Village of Lincolnwood Plan Commission

Meeting
Wednesday, October 14, 2015
7:00 P.M.

Plan Commission Staff Report

- Submit Sign Package and locate on site plan location of any freestanding sign(s).

NORTHEAST PARKWAY

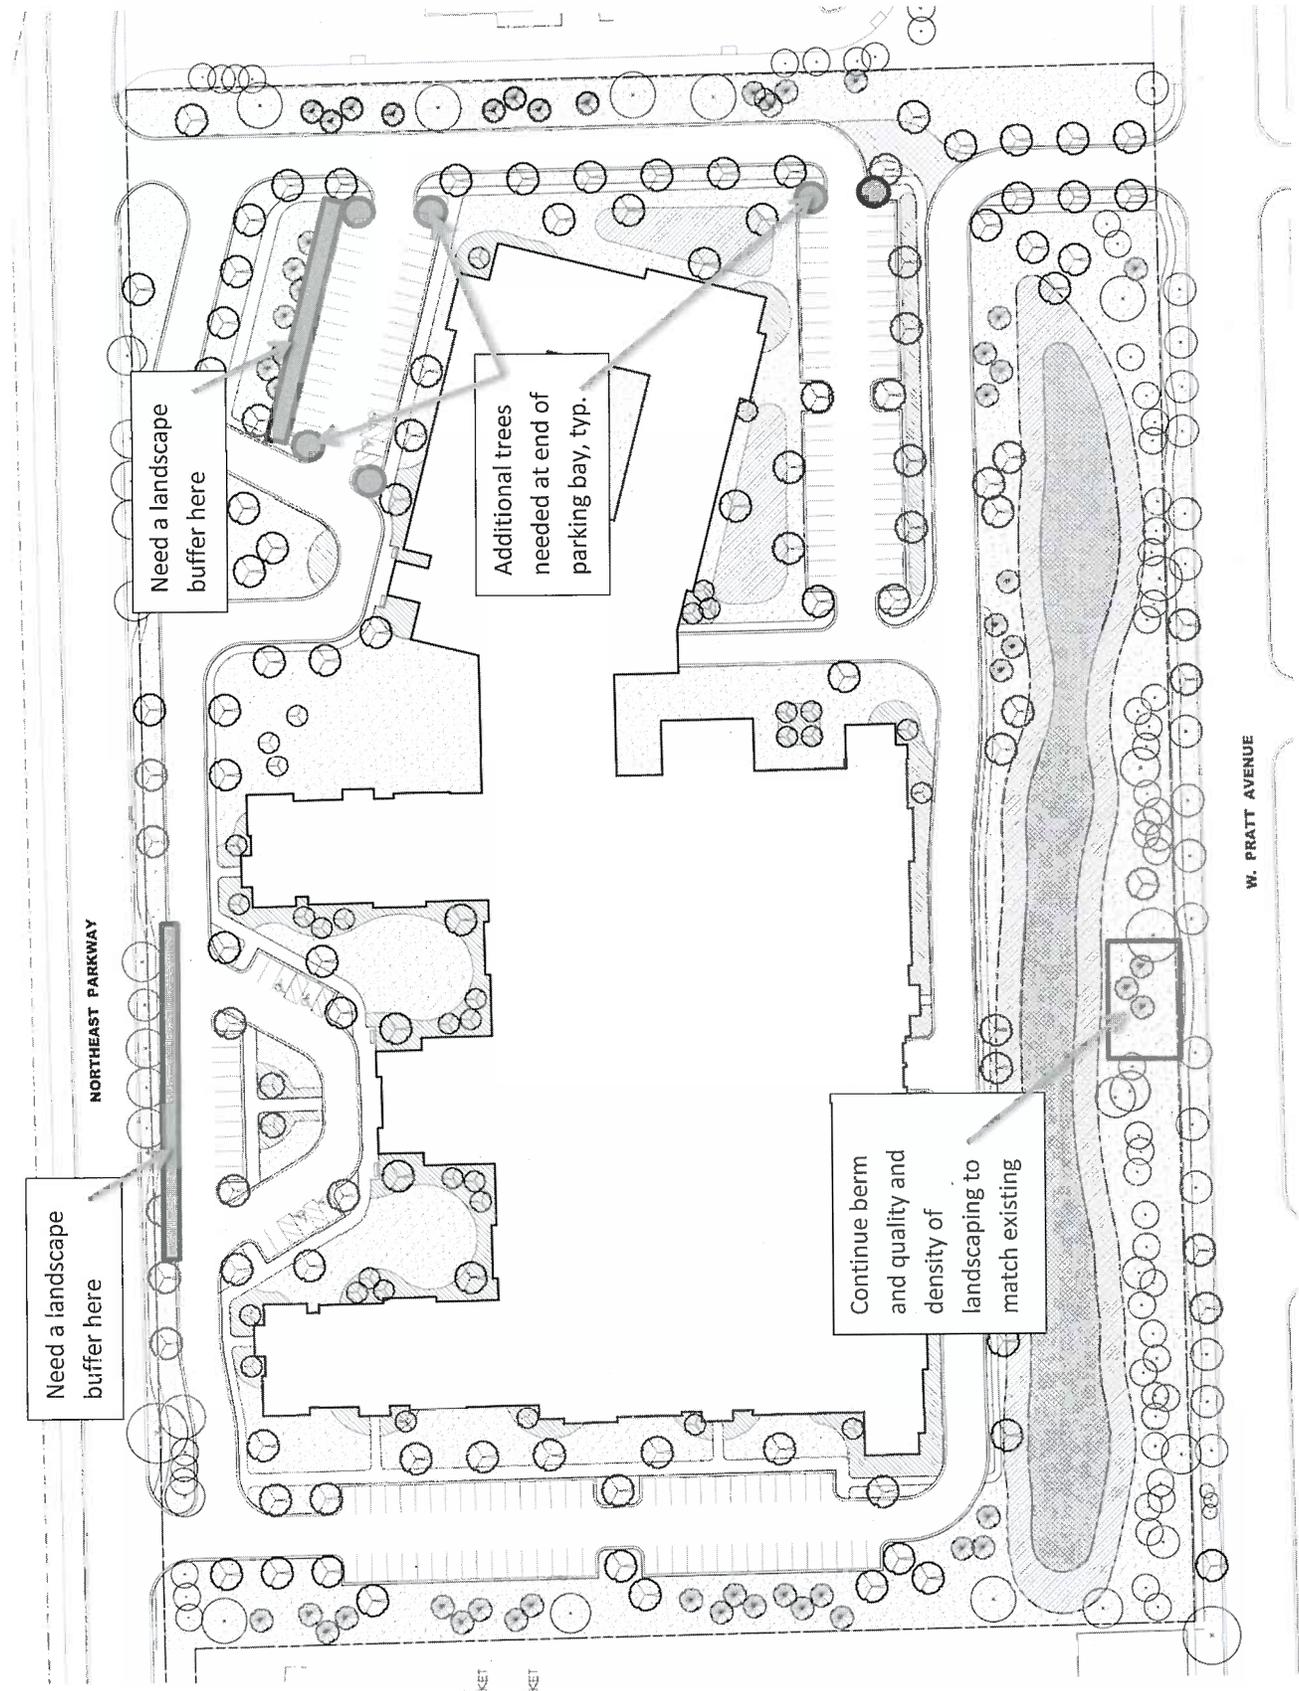
- The two parking lots on the north side of the development will need landscape buffers along the street side. See attached Illustration.
- All planting beds at the ends of the parking bay rows need to have trees as indicated section 6.14, item (2) b. See attached Illustration.

Need a landscape buffer here

Need a landscape buffer here

Additional trees needed at end of parking bay, typ.
